Town of Baldwin
Planning Board Meeting 11/11/21

Agenda Item – Sebago Road Solar

SEBAGO ROAD SOLAR

**CONDITIONAL USE APPLICATION FOR PLANNING BOARD REVIEW
SUPPLEMENTAL INFORMATION
Sebago Road Solar, LLC
6 Carl Burnell Road, Baldwin**

SHEET TITLE: SITE LAYOUT PLAN

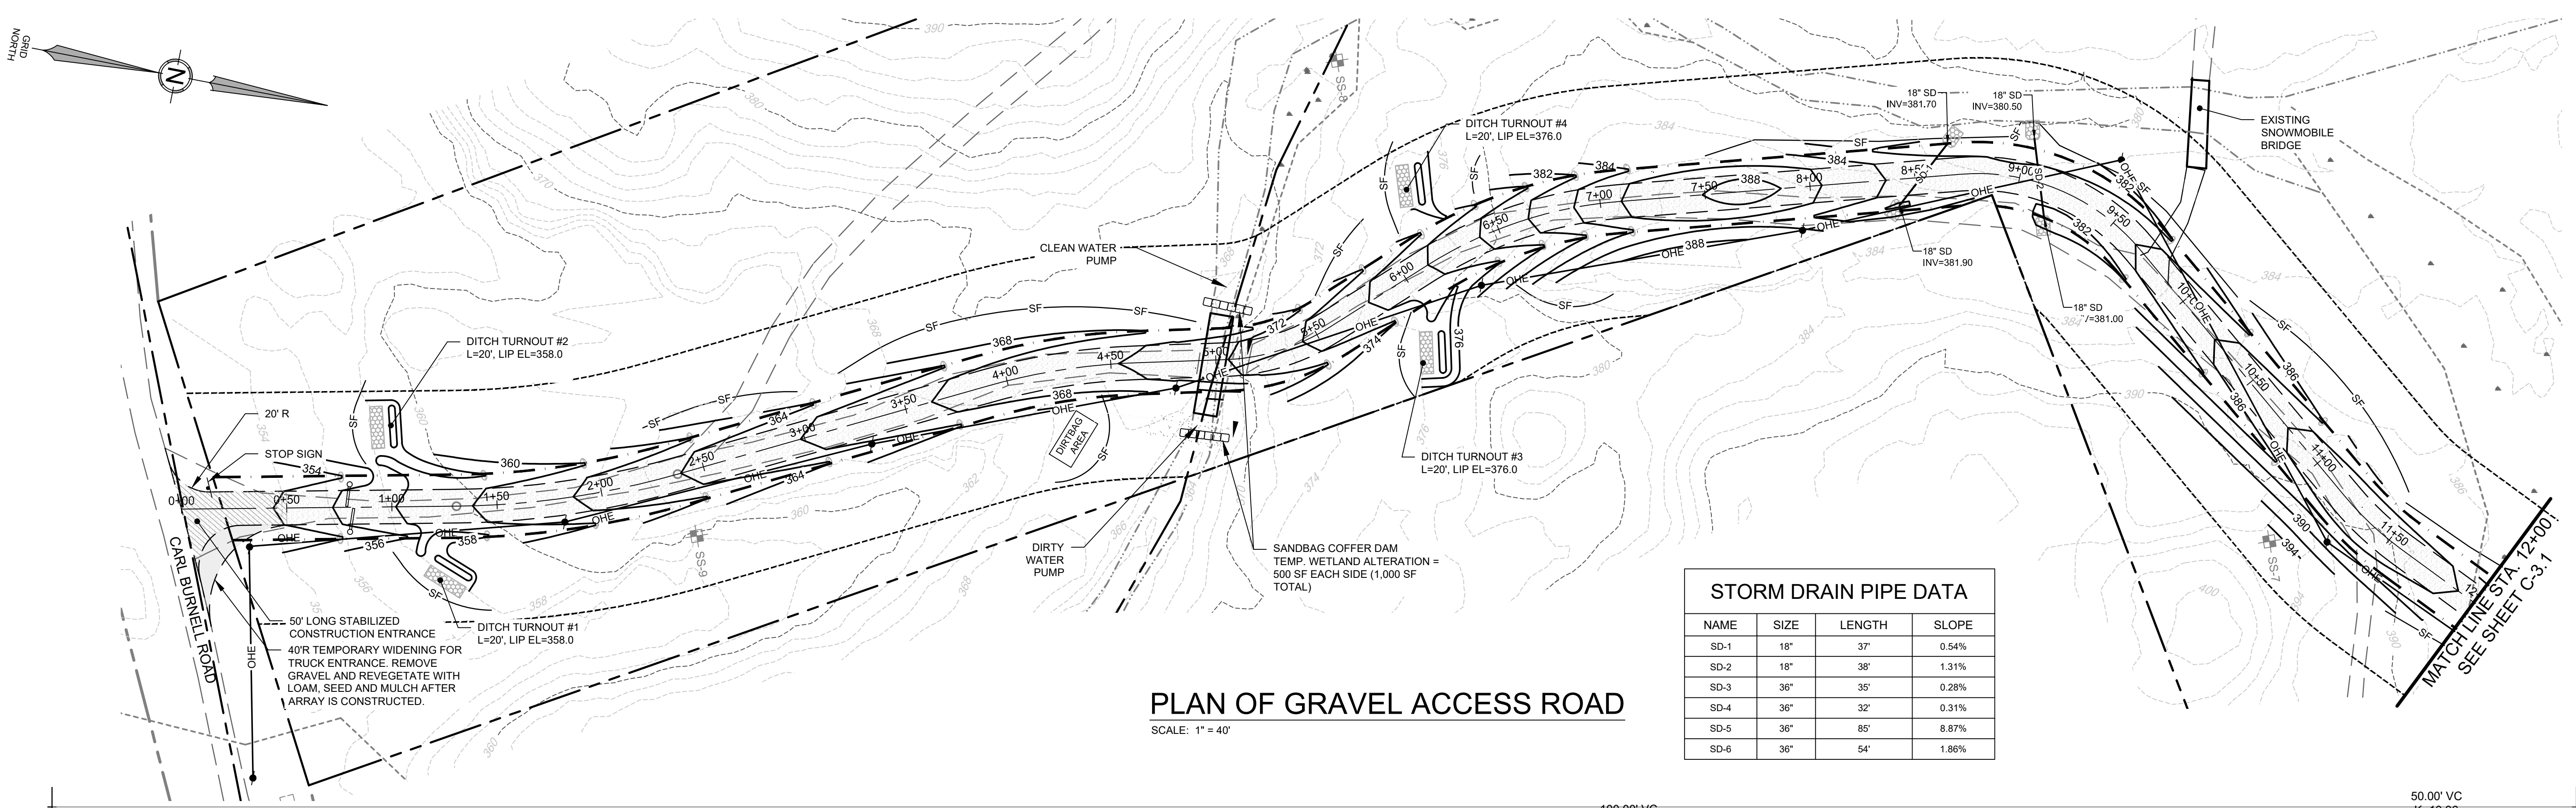
- Mr. Bastian notes that a gate is now shown on the plans and the shade management area. There was a short discussion of the need to have a right of way (60 feet if any property owners intend to have a house on the lot) to the back side of the property. Mr. Keller says that the green area of shade management is 100 feet.

3. Plan Revisions – The attached plan set has been updated to include items discussed at the October 28th meeting, including: gate on access road; lines and labels for vegetation management areas; boundary of solar development lease area; and drainage and construction easements outside of the lease area.

PROFILE OF GRAVEL ACCESS ROAD

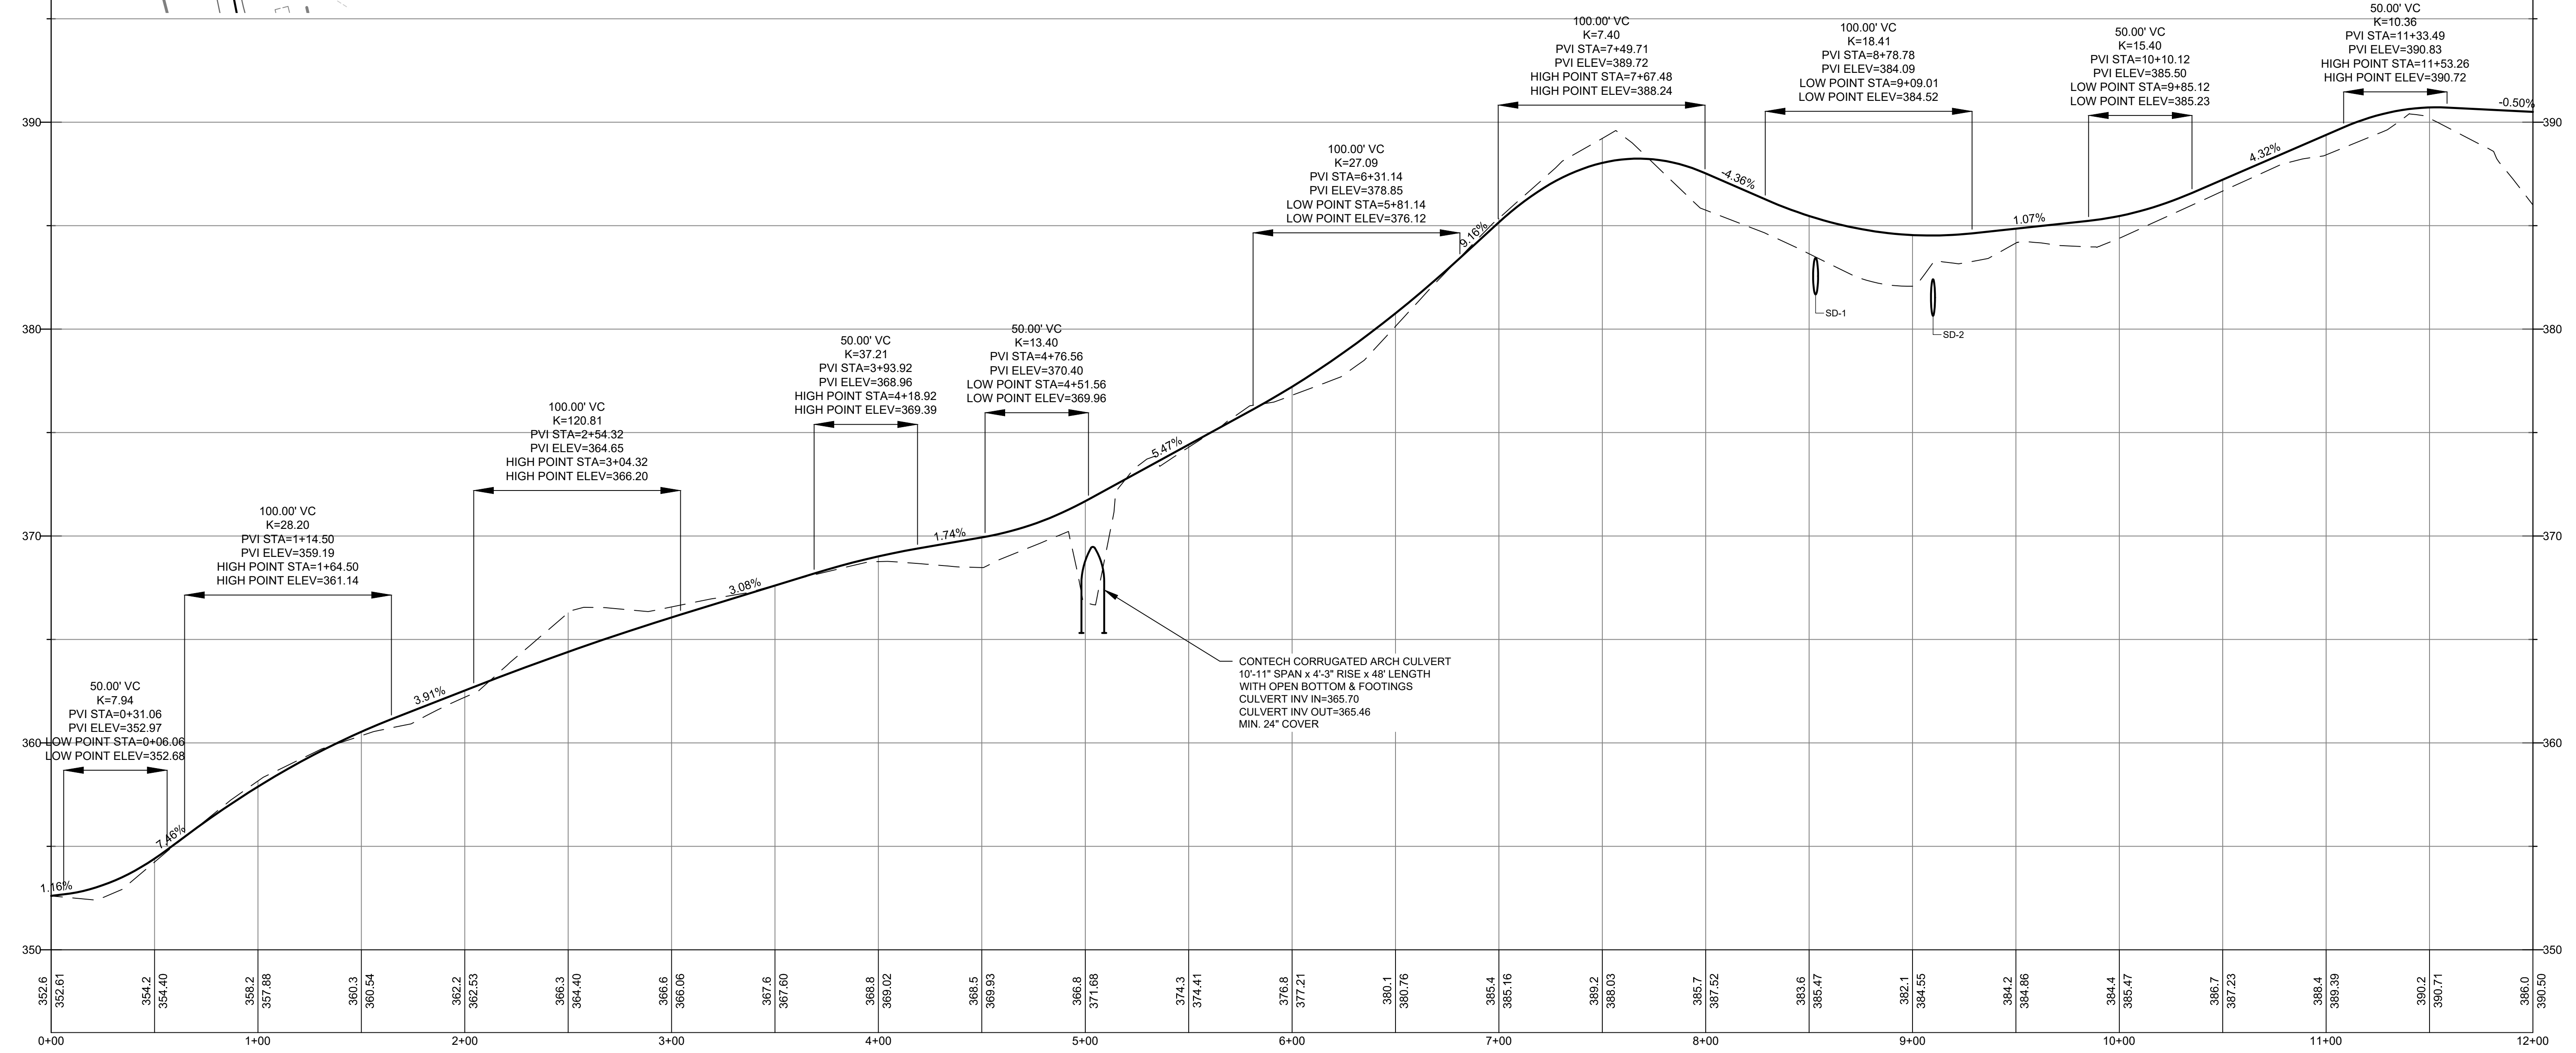
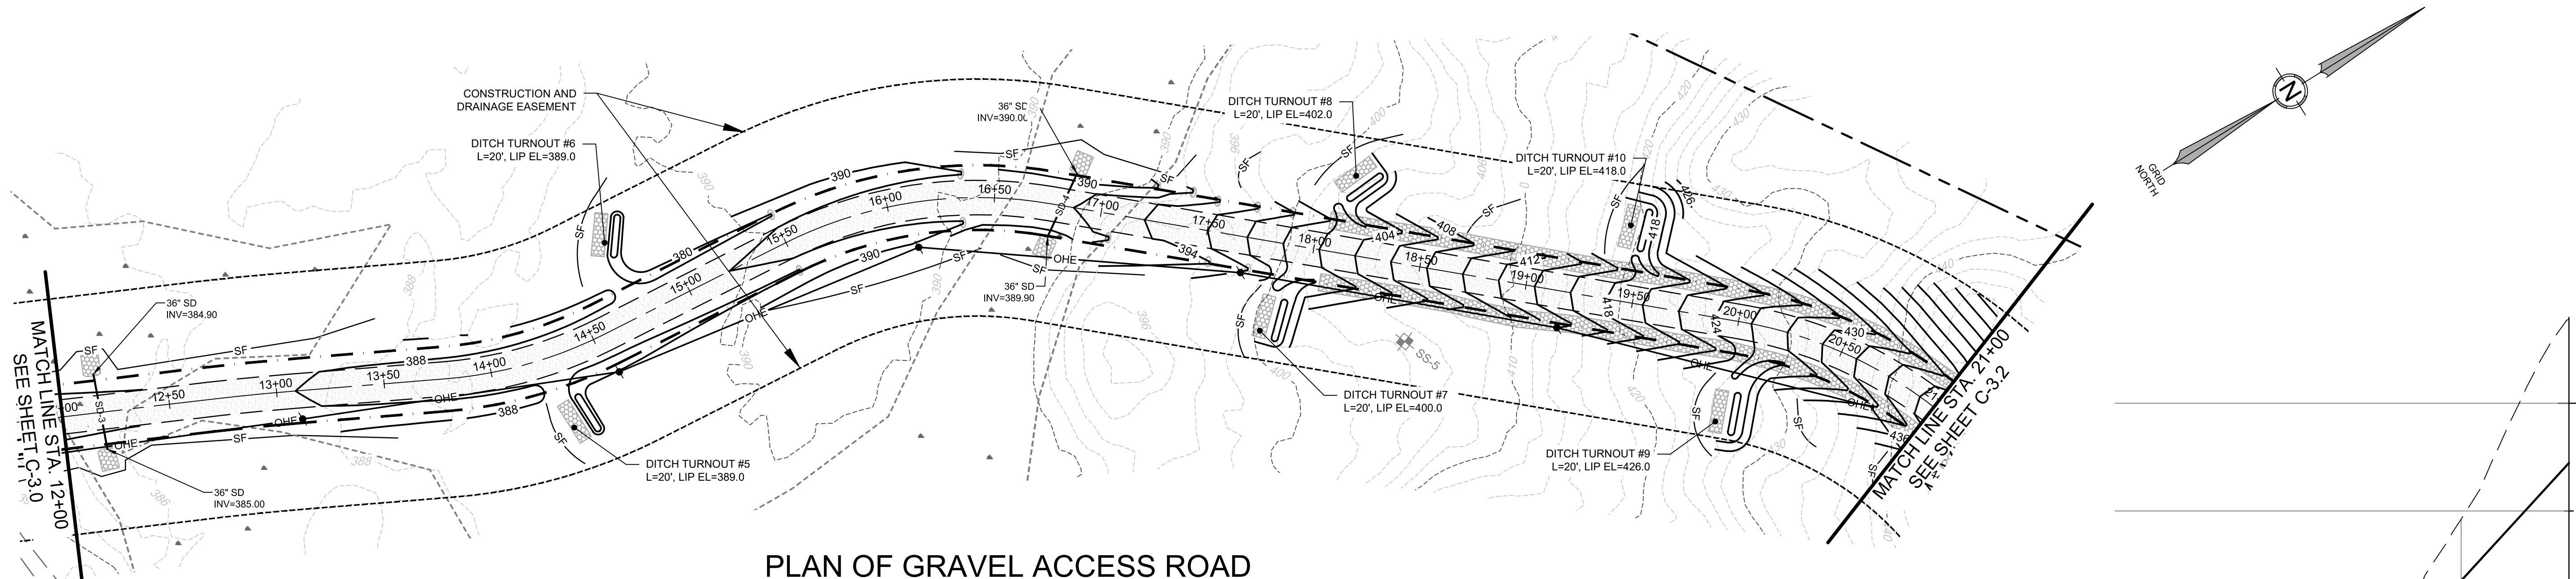
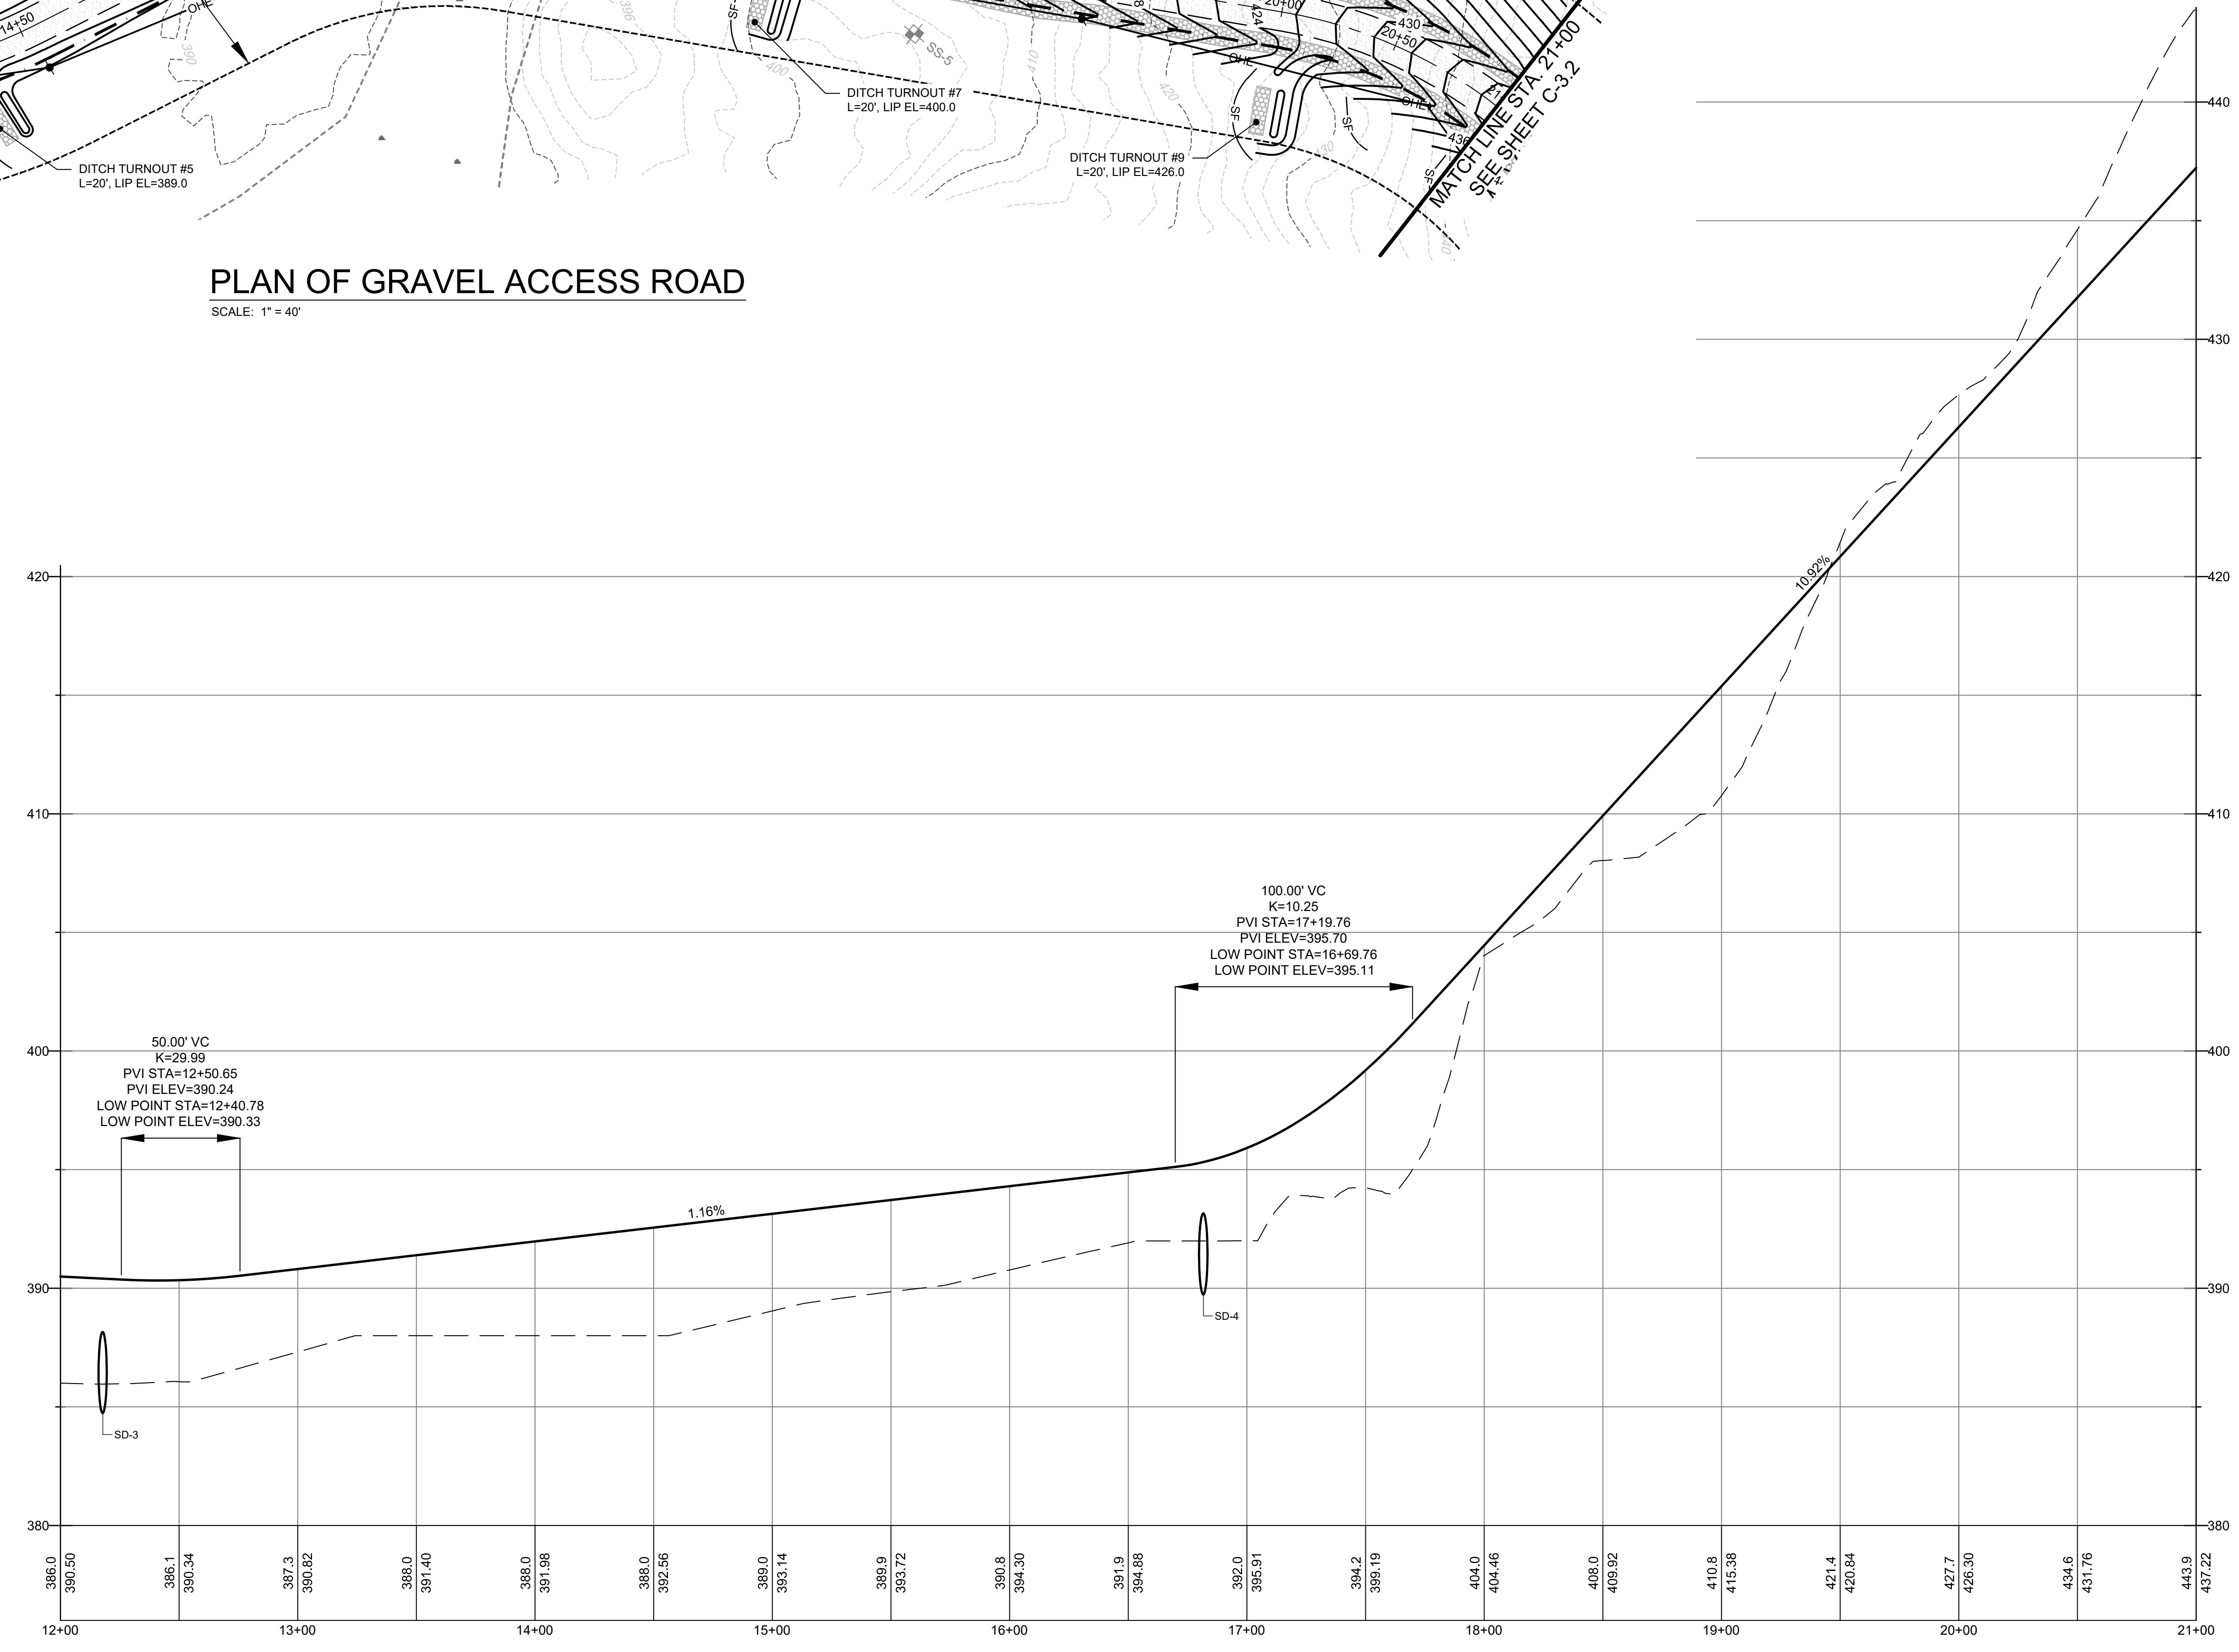
Mr. Fricker said that he hoped the applicant would address the 11% grade during the winter and whether that would be an issue. He wants to make sure the applicant has a plan for winter access. The new submissions are attached.

- Mr. Bastian said that he reached out to area contractors about the 10 or 11 percent grade an issue for construction and they said it should be fine if it is a well compacted gravel access road. In response to a question, he stated that the acces road will need to be well maintained during the winter with plowing and salt.
